# **Supporting material for comments against Clause 91 RS-FEC**

Adam Healey  
LSI Corporation

IEEE P802.3bj Task Force  
January 2013

Figure 91–9—FEC alignment state diagram

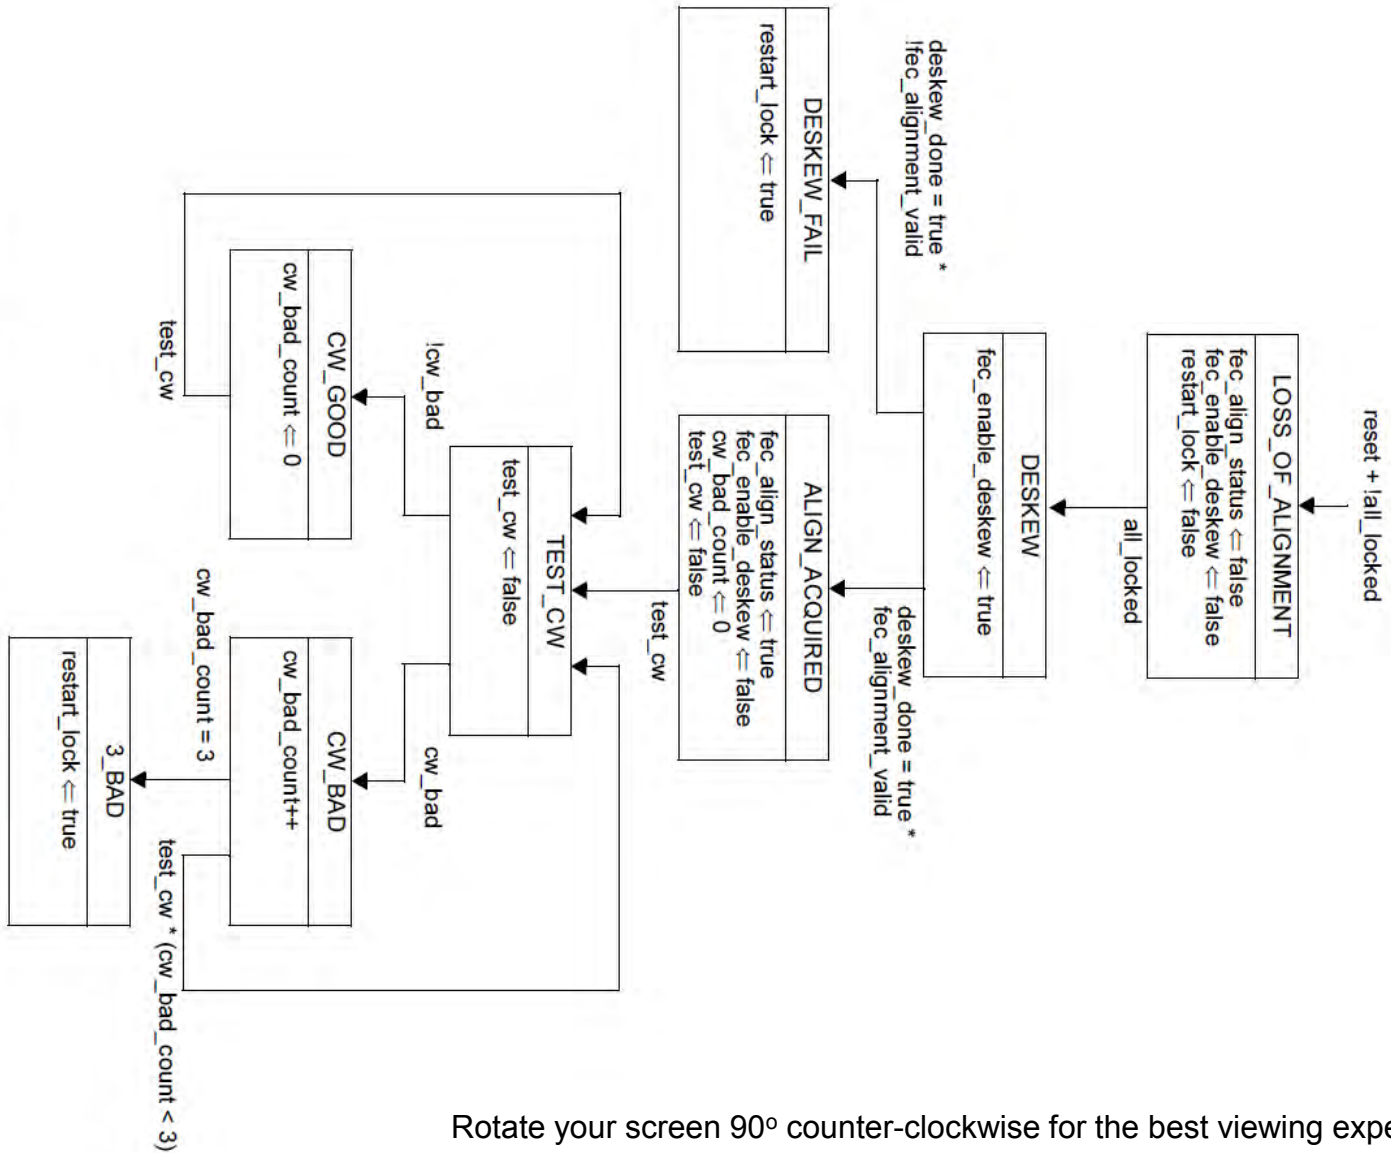
# Comment #244

- FEC synchronization and alignment state diagrams deadlock when `all_locked` is true but `fec_alignment_valid` is false
- This can occur if the lane-to-lane skew exceeds the RS-FEC deskew capability
- This can occur if `amps_lock<x>` is set to true at the incorrect starting bit position for FEC lane x
  - A random 64-bit block matches a valid alignment marker payload (to within 3 nibbles) and...
  - The 64-bit block `amp_counter` bits away from the first block matches the same alignment marker payload (to within 3 nibbles)
- Despite the low-likelihood of these (or other) cases, deadlock conditions should be avoided

# Modify FEC alignment state diagram, Figure 91–9

# Add new state variable

deskew\_done

A Boolean variable that is set to true when fec\_enable\_deskew is set to true and the deskew process is completed. Otherwise, this variable is set to false.
